MEMO

RE: Supplemental Application Materials for
VR-2018-005, NR-2018-002, and DEV-2018-006

HARMONY PARK TOWNHOMES PH II

PARKING/SIDE YARD
 /WQR PLANTING
 AREAS PLAN
 SEPTEMBER 4, 2018

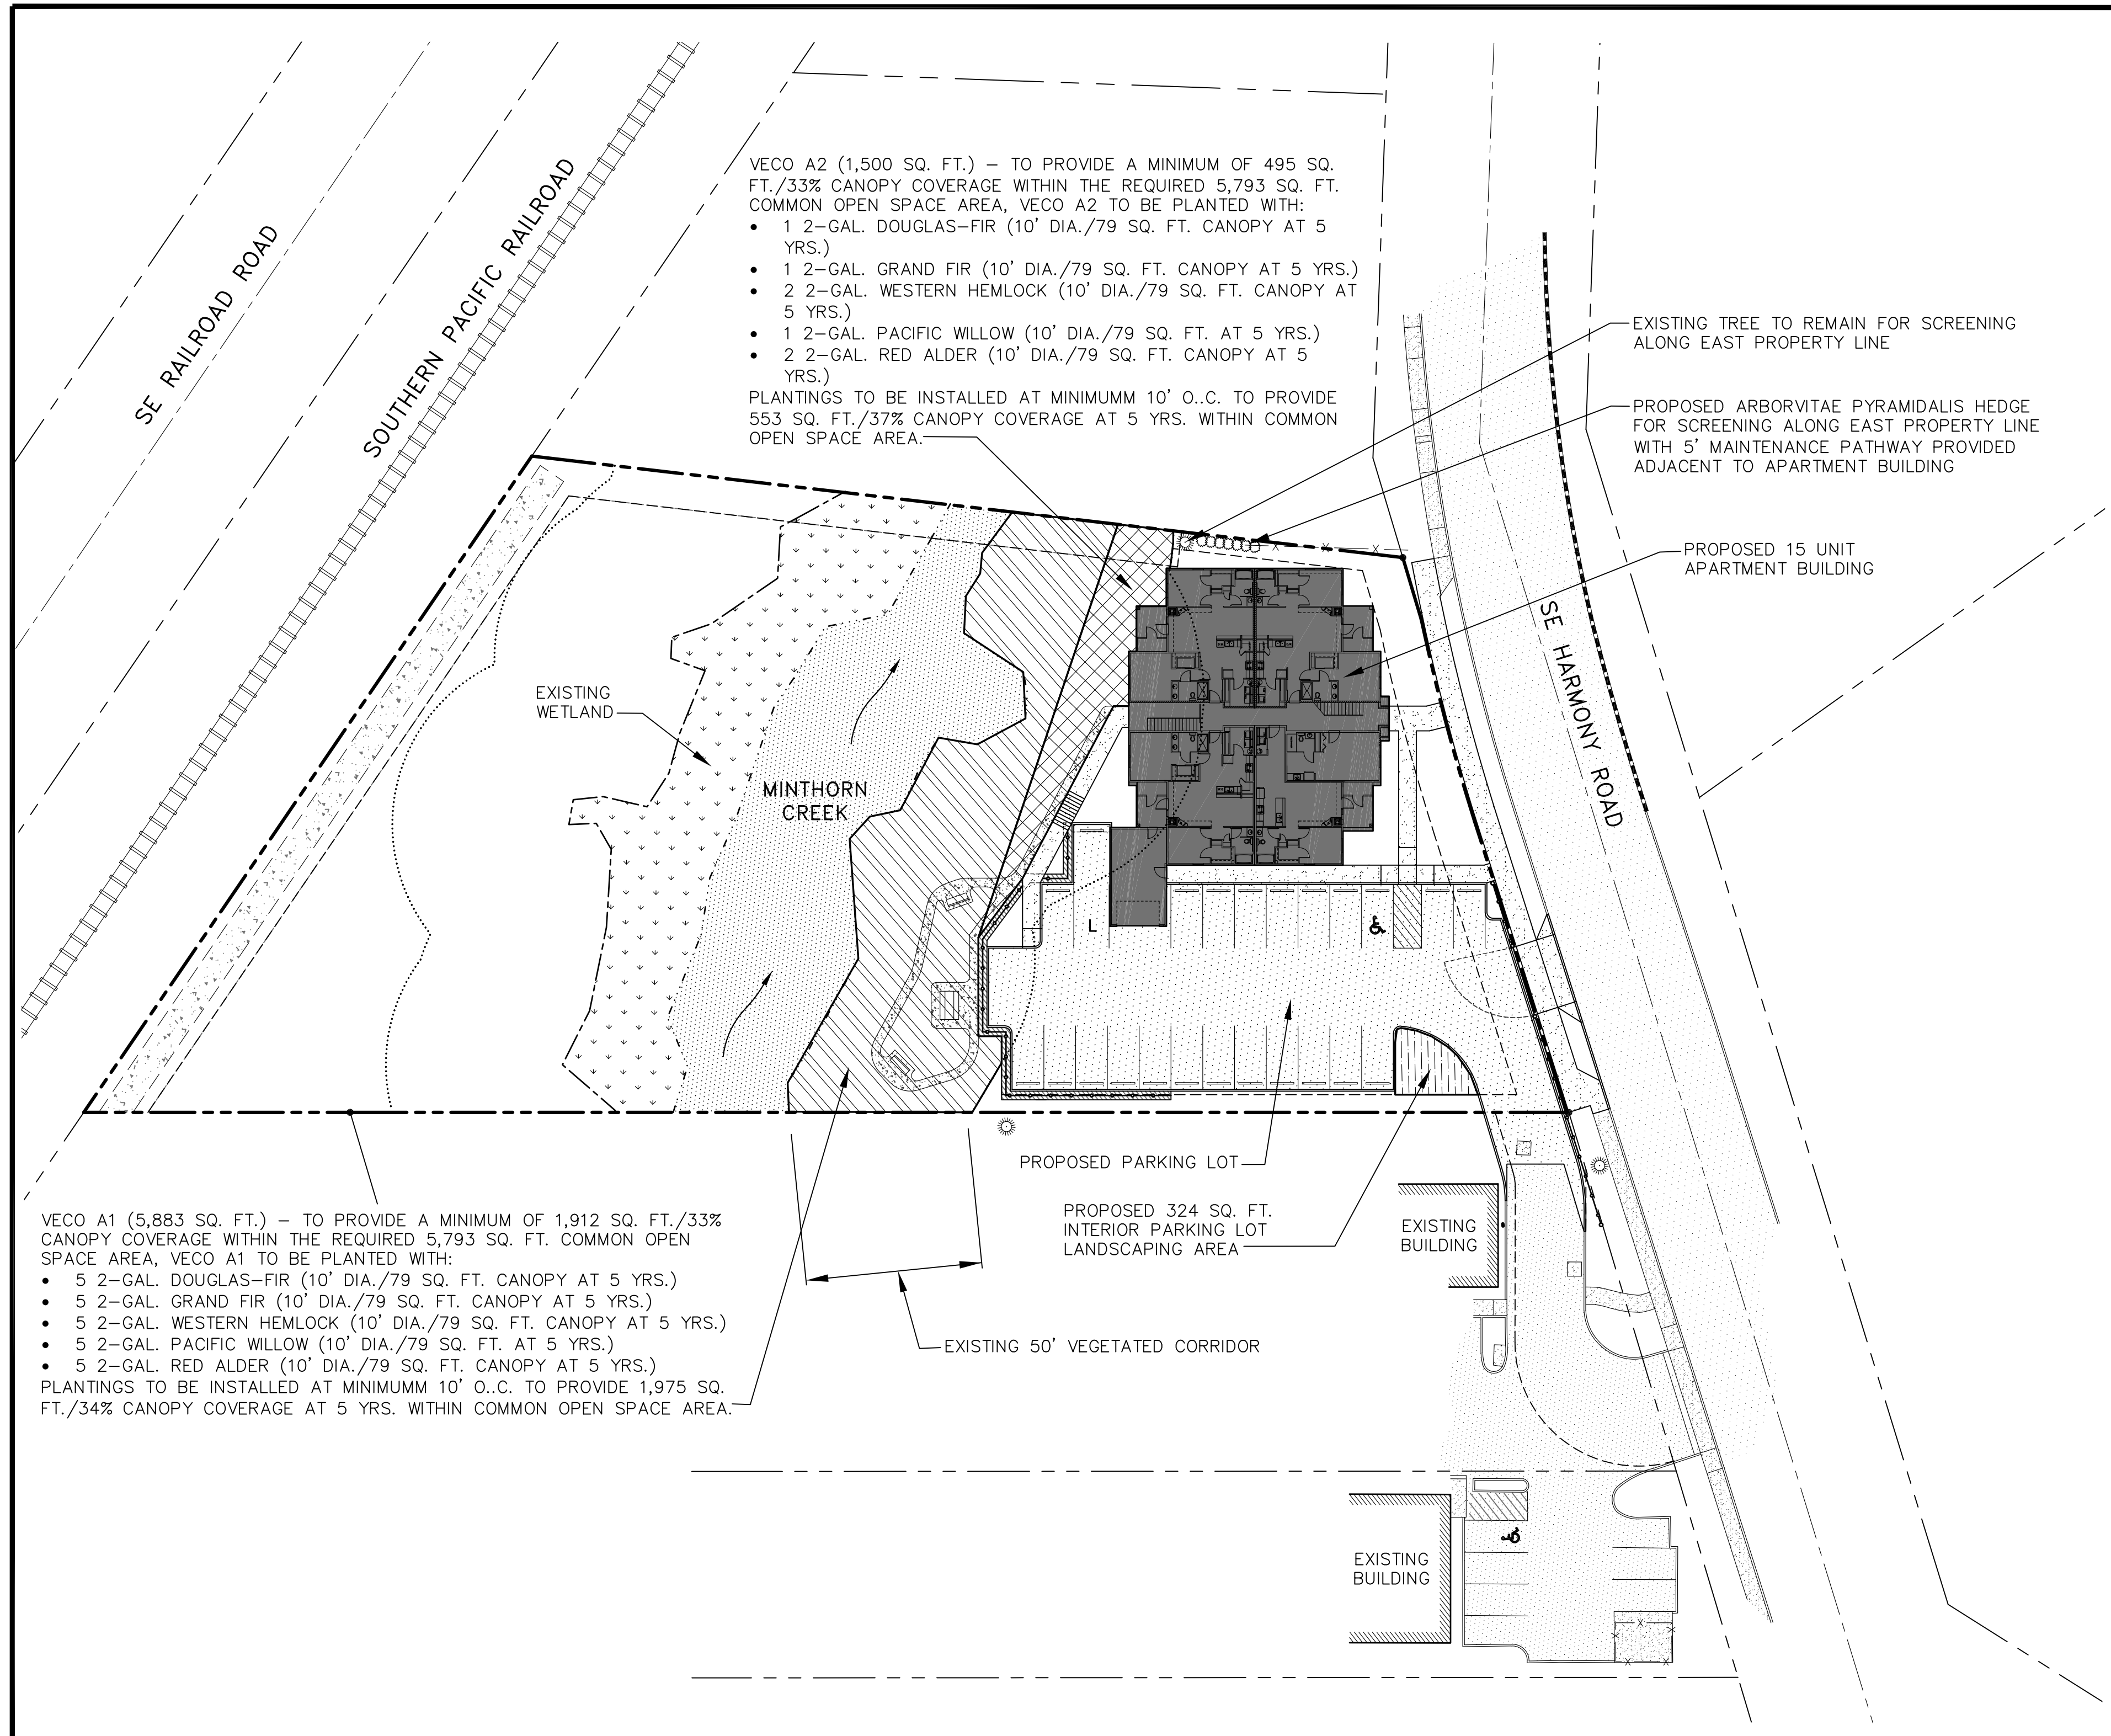
Item 1a. There is a Discrepancy between the Water Quality Site Assessment and the Proposed Planting Information for VECO A1 on Sheet P-6.

Item 2e. It is Unclear What Percentage of Canopy-Coverage will be Provided for VECO A2.

Item 3a. The Interior Landscaping Standard does not Appear to be Met. It may be Necessary to Expand the Parking Lot Landscaping Variance to Include Interior Landscaping with an Exploration of Mitigation Measures.

The proposed planting information provided on Sheet P-6 replaces what was previously presented in Table 2 of the Water Quality Site Assessment for VECO A1.

The applicant has revised Sheet P-6 to provide proposed plantings for VECO A2. The revised planting list will provide 37% canopy coverage within 5 years for this portion of the common open space area. The planting information provided on Sheet P-6 replaces what was previously presented in Table 3 of the Water Quality Site Assessment for VECO A2.

Based on Staff's feedback, the applicant has revised Sheet P-6 to exclude some of the area that was previously illustrated as interior landscaping. The plan now indicates that the interior landscaping area totals 324 sq. ft. when 575 sq. ft. is required to meet the standard. The applicant is therefore expanding the variance request from only parking lot perimeter landscaping to parking lot landscaping in general. The applicant's revised response to the parking lot landscaping variance under the Discretionary Relief Criteria of Section 19.911(4)(B) is provided below:

APARTMENT BUILDING
ELEVATIONS

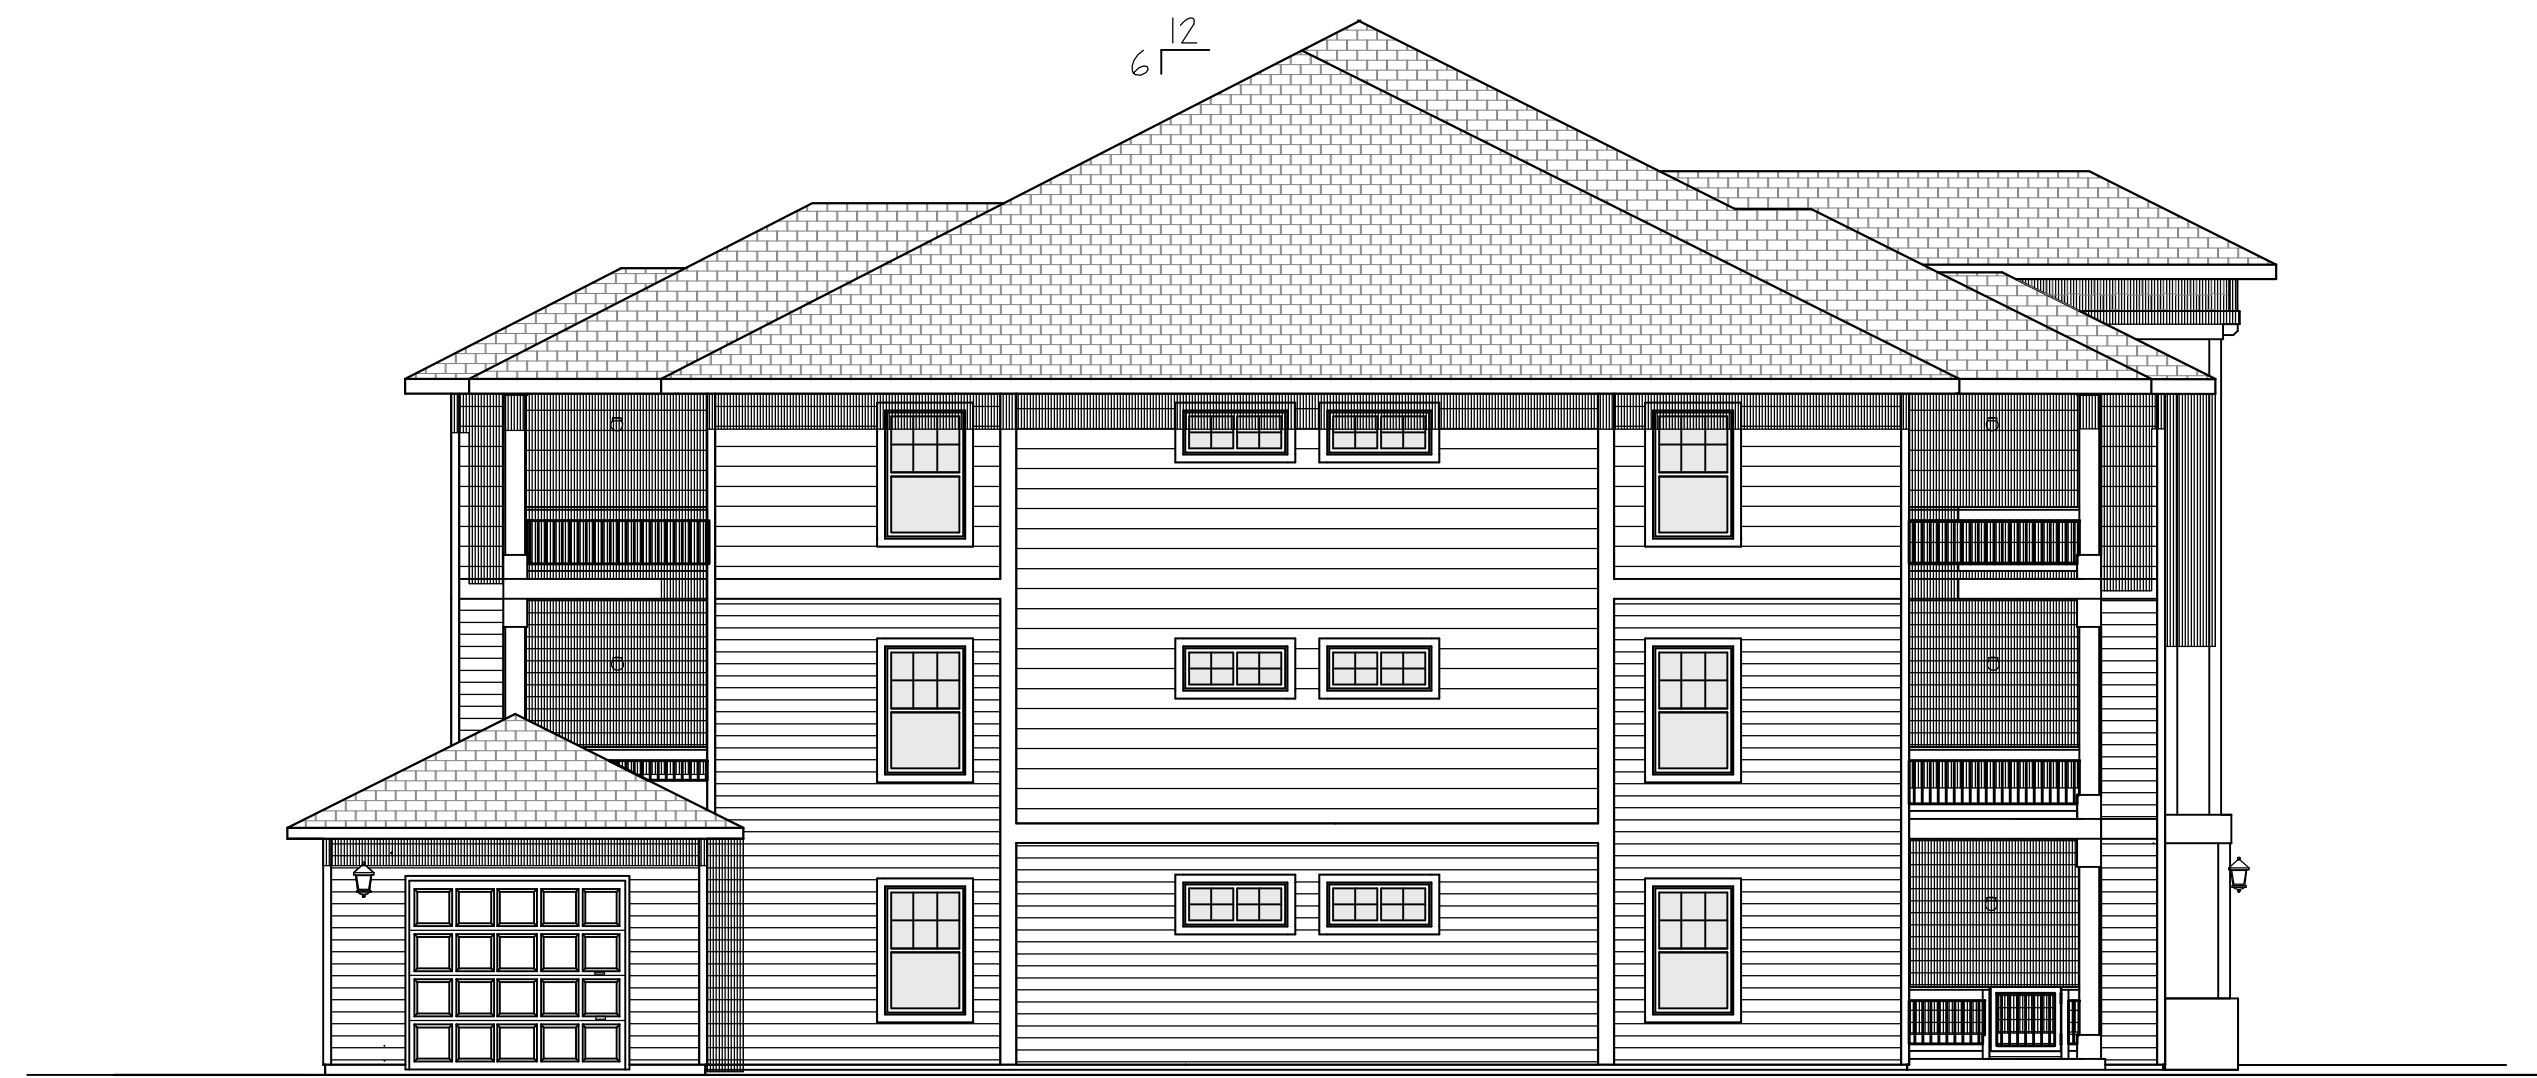
Item 2c. *Staff Asserts that Stone Veneer and Cedar-Shake Patterned Hardi Board do not Function to Create a Simple and Visually Interesting Building. It is Unclear How the Doors and Windows will be Inset to Provide Depth, Shadows, and Expression to the Building.*

The attached Building Elevations have been revised to remove the stone veneer and cedar-shake patterned Hardi Board from the proposed multi-family structure. To provide depth, shadows, and expression to the building, the applicant is proposing to install 1 ½" thick trim around the proposed exterior doors and windows versus installing the industry standard 1" thick trim.
